SERVICE BULLETIN NO: 30-009

ICE AND RAIN PROTECTION - WINDSHIELD DEICE SYSTEM WINDSHIELD DEICE SYSTEM WIRING - INSPECTION

Wiring Diagram - Left Windshield Deice System
Figure 1

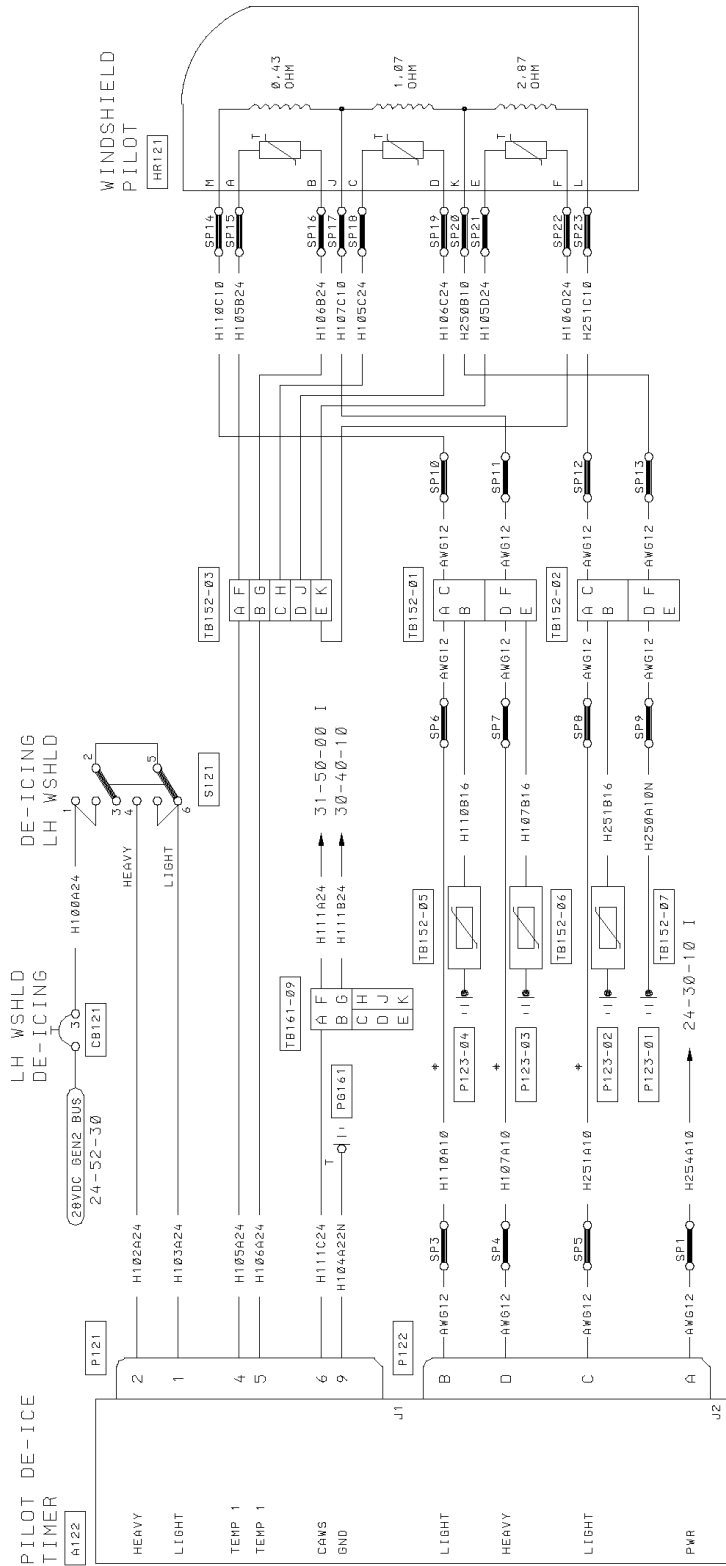
It is possible for heat damage to occur in given wires in the deice systems of the left and/or right windshields in some PC-12 and PC-12/45 aircraft.

This problem has only occurred in a windshield deice system in which wires of incorrect gage were used.

- (1) Do an inspection of the wires, splices and related link wires in the area of terminal block (TB152) for signs of heat damage (Ref. Table - Wire, Splice and Link Wire Assemblies - Inspection). Heat damage is not permitted. Replace all damaged wires and link wires (Ref. Para C).
- (2) Do a check of the wires and related link wires to make sure that they are correct as specified (Ref. Table - Wire, Splice and Link Wire Assemblies - Inspection and WM, 30-40-00 and 30-40-10).

- Do an inspection to make sure the wires installed in the windshield deice systems agree with the specifications given in the applicable wiring diagrams
- Replace all incorrect wires

- (1) Fully remove the flight-compartment overhead panel for access to terminal block TB152 (Ref. AMM, 25-10-03, Page Block 401).
- (2) Replace damaged or incorrect wires as necessary (Ref. WM, 30-40-00 and 30-40-10).
